Re: Duane Arnold Energy Center

EXEMPTION

SAFETY EVALUATION BY THE OFFICE OF NUCLEAR REACTOR REGULATION

TECHNICAL EVALUATION REPORT

Figure 1.

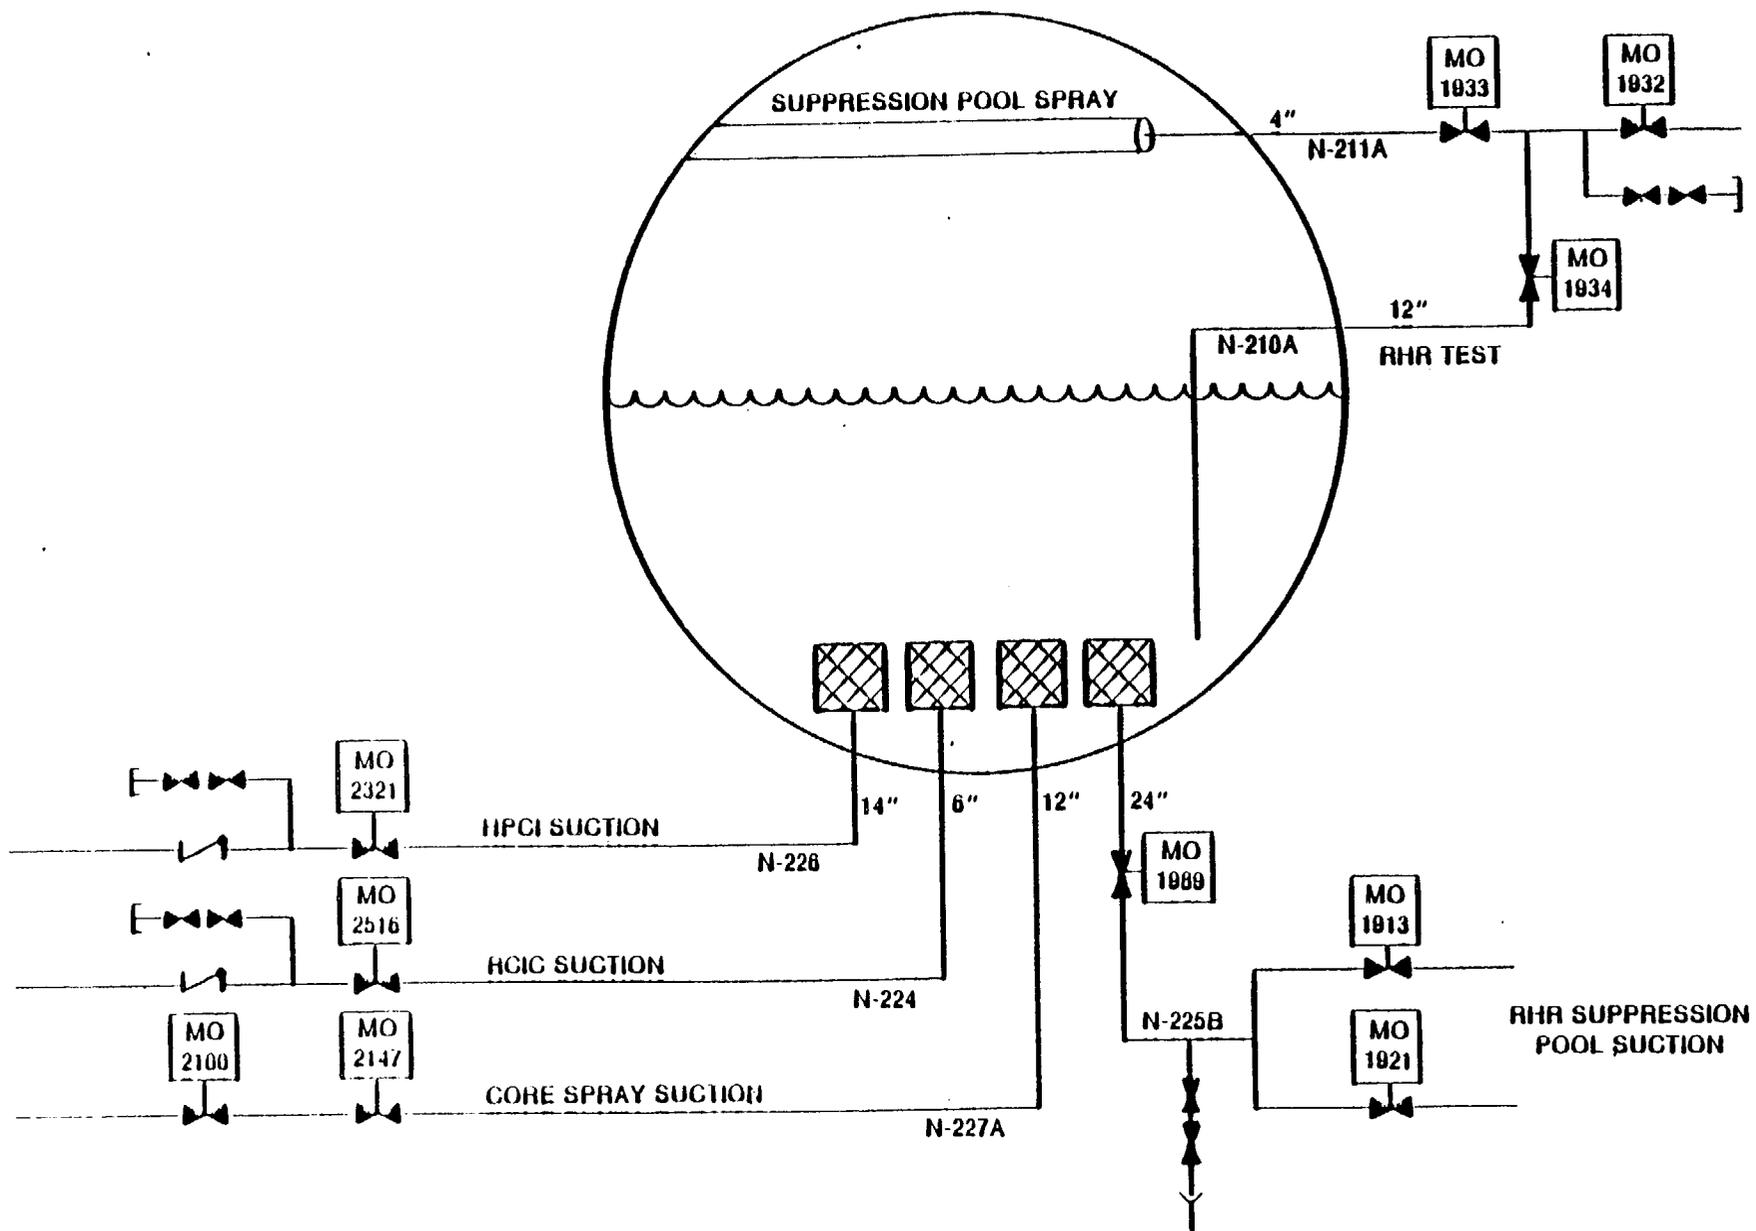
The piping configurations of concern are presented in Figures 1 and 2. Figure 1 shows the HPCI, RCIC, and core spray suction lines and one loop of the suction, suppression pool spray, and RHR test lines. Figure 2 shows one loop of LPCI injection, RV head spray, and containment spray. As can be seen in Figure 1, the HPCI, RCIC, core spray, and RHR suction lines are isolated from the containment atmosphere by the water level in the suppression pool. Since these lines are continuously water filled in a post-accident condition,

the isolation valves are not relied upon to prevent the escape of containment air to outside atmosphere; therefore, Type C testing is not required by Appendix J. Similarly, because the RHR test line terminates below the level of the pool, its isolation valve is also isolated from containment atmosphere, and Type C testing of this line is not required.

In summary, Type C testing is not required and no exemption is necessary for the following penetrations because Appendix J does not require testing: N-210A & B, N-224, N-225A & B, N-226, N-227A & B, and X-17. For penetration X-39A & B, the inboard isolation valves should be tested in the direction of accident pressure or by pressurizing between the inboard and outboard isolation valves in order to test the valve packing and body-to-bonnet seals of the inboard valves. For penetration N-211A & B, the inboard isolation valves should be tested in the direction of accident pressure or by pressurizing

Figure 2.

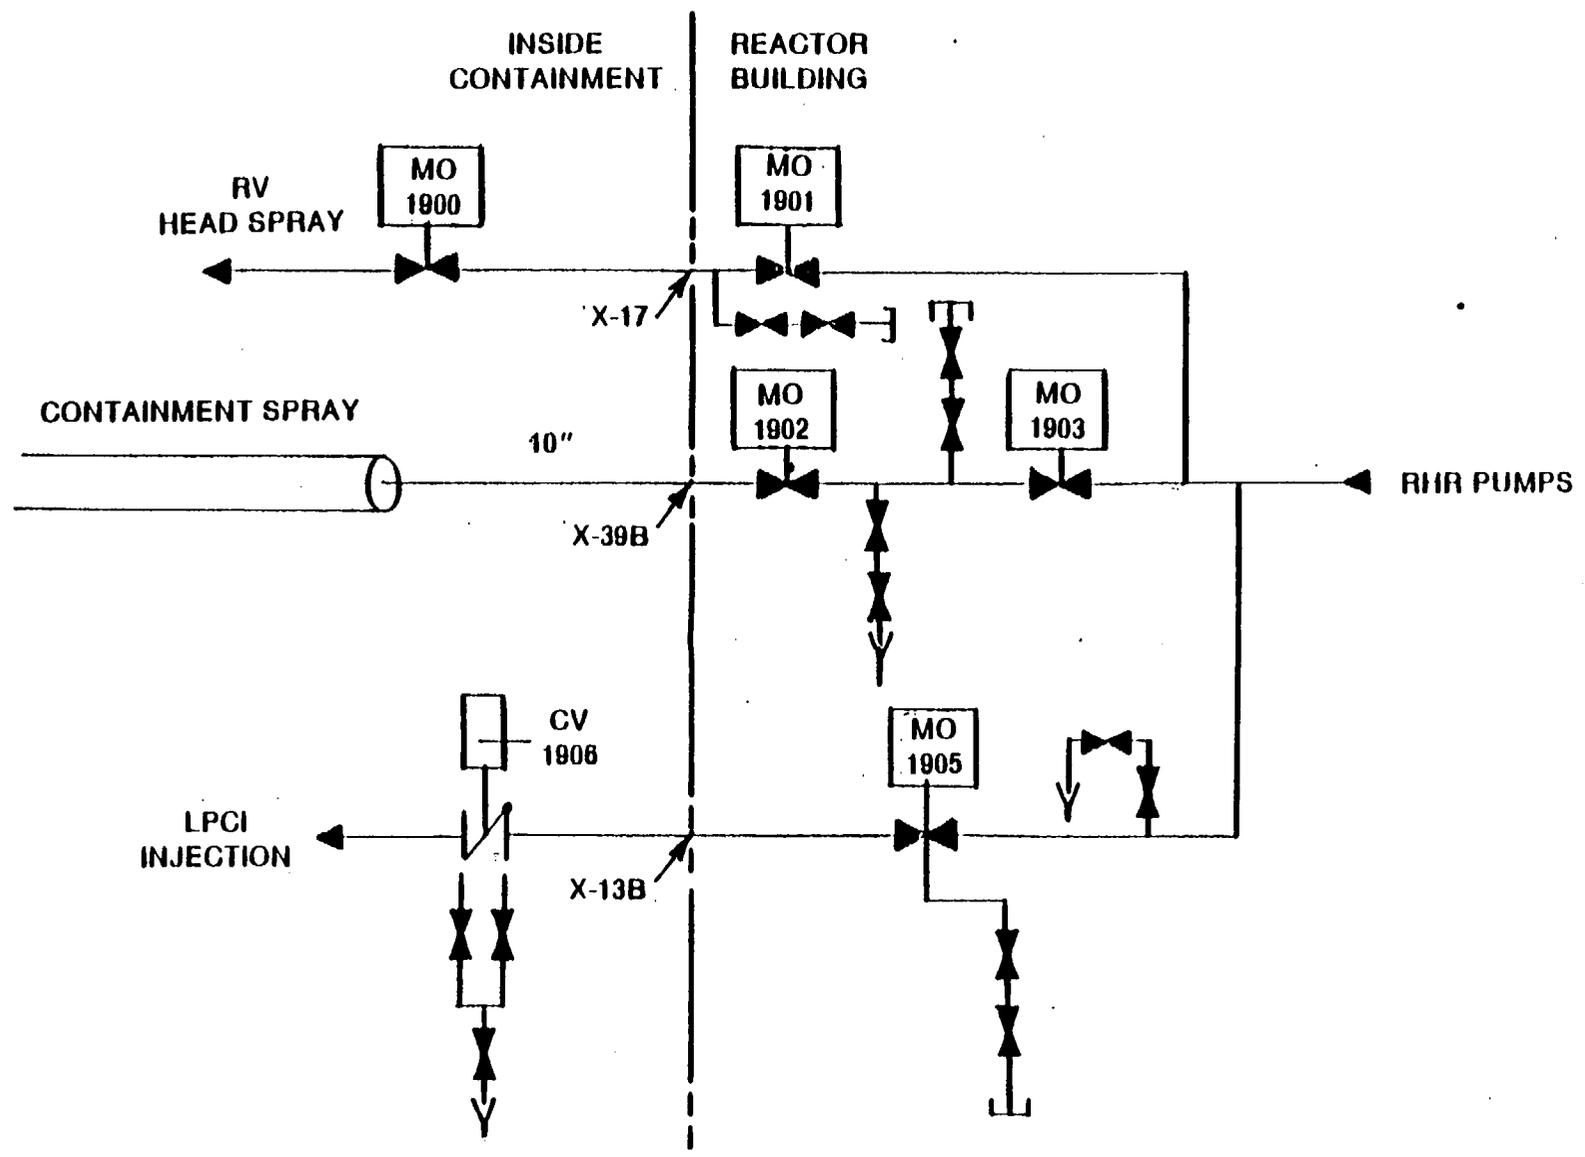
The LPCI injection line will be normally open and filled with water at a pressure greater than containment accident pressure as soon as safety injection is initiated. Furthermore, should valve MO-1905 (Figure 2) fail to open, the valve will be water sealed by RHR water at pump head pressure, and no single active failure can cause a loss of this pressure. Since MO-1905 is a gate valve, the water pressure will unseat the upstream valve disc and pressurize the valve packing and body-to-bonnet seal area with water. Consequently, there is no path for containment air leakage to the atmosphere through this line, even in the case of air leakage past the seat of check valve CV-1906. Therefore, this line is not a potential source of containment atmosphere leakage and the isolation valves are not required to be Type C tested in accordance with Appendix J.

Unlike the LPCI injection line the remaining three lines (suppression pool spray, containment spray, and RV head spray) are not automatically initiated by safety injection. Flow in these lines is left for manual initiation, if necessary, once sufficient reactor vessel level has been reestablished. Depending upon the severity of the accident, flow in these lines may not be established (particularly containment spray and suppression pool spray). Furthermore, at the start of an accident, there is no guarantee that there is any water in the line between the inboard and outboard isolation valves. In the case of these lines, therefore, there is a potential for containment air to escape to the outside atmosphere through the valve packing or body-to-bonnet seal area of the inboard isolation valve, even though the outboard valve is water sealed, as described in the case of valve MO-1905 of the LPCI injection line.

In the case of the reactor vessel head spray line, the inboard isolation valve is located inside containment (e.g., valve MO-1900). Leakage through the valve packing or body-to-bonnet seal is not a concern since any leakage is

For both the containment spray line and the suppression pool spray lines, however, the inboard isolation valves are located outside containment (e.g., valves MO-1902, MO-1933, MO-1934). If any of these valves leak through the packing or body-to-bonnet seals, the leakage of containment air reaches the outside atmosphere. Consequently, Appendix J requires that these valves be Type C tested. However, since the packing and body-to-bonnet seals are the only potential sources of leakage, the testing may be limited to these particular areas. Valve MO-1902 in the containment spray line is also a gate valve. Testing this valve by pressurizing between valves MO-1902 and MO-1903 achieves the intent of Appendix J because this test will unseat the upstream disc of valve MO-1902 and will pressurize the area of concern. Valves MO-1933 and MO-1934, however, are globe valves. FRC does not have sufficient information to determine whether the packing area is isolated from the containment side of the line when the valve is shut. However, assuming this is the case, these valves may also be tested by pressurizing between valves MO-1932, MO-1933, and MO-1934 since the area of concern will be subjected to the test pressure. If this is not the case, valve MO-1933 must be tested in the direction of accident pressure (note: by pressurizing between the three valves, MO-1934 is tested in the direction of accident pressure since its function in this case is to isolate the suppression pool spray line rather than the RHR test line).

between the inboard and outboard valves provided that this testing will expose the packing and body-to-bonnet seal areas of the inboard valves to the test pressure.
